DEPARTMENT OF PLANNING
STAFF REPORT

BOARD OF SUPERVISORS PUBLIC HEARING

DATE OF HEARING: June 7, 2010
ZMOD 2008-0017, Belmont Executive Center Comprehensive Sign Plan
DECISION DEADLINE: July 6, 2010
ELECTION DISTRICT: Broad Run
PROJECT PLANNER: Sophia Fisher **DEPARTMENT DIRECTOR: Julie Pastor**

Sign types A1 and M1

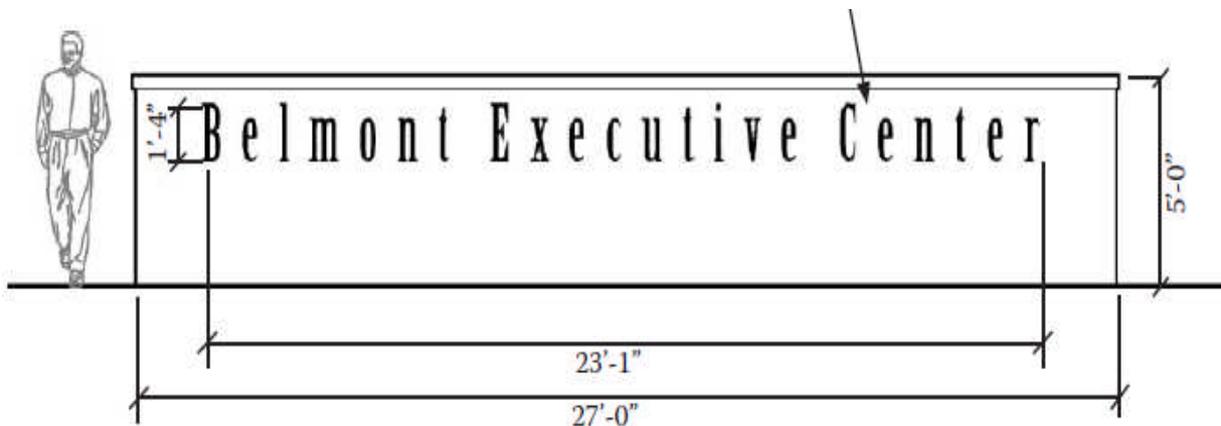
1. A1 and M1, project icon signs (modifying Sections 5-1204(D)(3)(k) development entrance signs and 5-1204(D)(3)(c), entrance signs). A1 and M1 are identical 5' by 27' monument signs. The A1 signs are located in PD-OP, while the M1 signs are located in PD-CC-CC. Both signs are classified as development entrance signs, and are intended to be at the vehicular entrance to the development. Two of the four signs are located at the intersection of Claiborne Parkway and Russell Branch Parkway. One is located adjacent to Route 7, where the off-ramp to Claiborne Parkway begins, and the final one is located on Claiborne Parkway just past the end of the off-ramp. None of the proposed A1 and M1 signs are located at vehicular entrances into the development. Entrance signs are to be located at the vehicular entrance into the development, not at the intersection of roadways or along interchange ramps.

Staff recommends that sign types A1 and M1 be removed from the comprehensive sign plan or relocated to vehicular entrances. However, staff notes that should the applicant choose to relocate the A1 and M1 signs, other signs such as the A2 signs should be removed so as to avoid the potential for visual clutter and confusion. It also appears that these two signs serve the same purpose and will be redundant, particularly when considered in conjunction with the Community Commercial Sector Sign (M2) proposed at the main entrance to the retail center.

Sign type M2, as shown in the Comprehensive Sign Plan (top) and in a 3-D rendering (bottom)

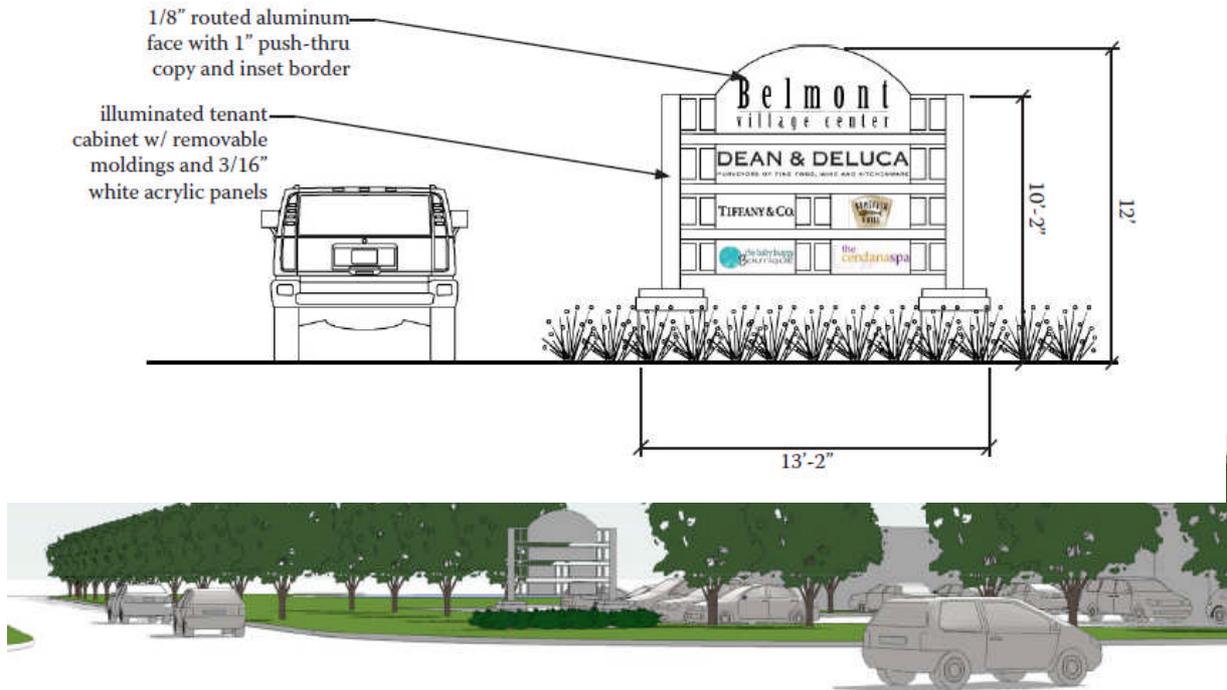
2. M2, community commercial sector signage (modifying Section 5-1204(D)(3)(c), entrance signs). M2 is the monument sign for the retail center. Although it has been reduced from 20' tall by 21 ½' wide to 12' tall by 13'2" wide, the sign still appears to be out of scale for the amount of retail in the Belmont Village Center, zoned PD-CC-CC (Planned Development – Commercial Center – Community Center), which is intended to serve the retail shopping needs of the surrounding communities. As such, most of its users will be familiar with the center once it has been operating for a short period of time and will not

need a significant number of large signs identifying specific tenants at entrances. Furthermore, many of the retail tenants will be easily visible from the surrounding roadways of Russell Branch Parkway and Claiborne Parkway and the proposed sign plan includes significant modifications regarding the size and number of building-mounted retail signs. The main concern is the background structure. The proposed height of 12' is on par with the monument signs at Lansdowne Village Green, Goose Creek Village Center, and the Village Center at Belmont Greene. However, the proposed width of 13'-2" is significantly wider, leading to an excessively large monument sign. The proposed sign panels, at 51 ½ SF per side are on par with sign panels approved elsewhere in the county.

Staff recommends that the width of the background structure of the sign be reduced to 8'8", to be compatible with other retail monument signs at other PD-CC-CC centers in the area such as Goose Creek Village, Lansdowne, and The Village Center at Belmont Greene. The background structure for the proposed M2 sign is 13'2" wide (1'2" or 10% wider than the sign for Belmont Greene) at the base and 11'4" wide at the top (2'8" or 31% wider than Goose Creek Village Center). Staff does not object to the width of the sign panel, which is 7'4" wide, nor to the area of the sign itself. However, retail monument signs approved for PD-CC-CC centers have grown steadily in width from Lansdowne (7'10", approved 2006) to Belmont Greene (8', approved 2008) to Goose Creek Village Center (8'8", approved 2009), an overall increase of almost 11% from Lansdowne to Goose Creek Village Center.

The Planning Commission recommended that the sign remain unchanged, but that language be added to the Conditions of Approval holding the applicant to construct the sign as designed. This language has been added per the Commission's recommendation.
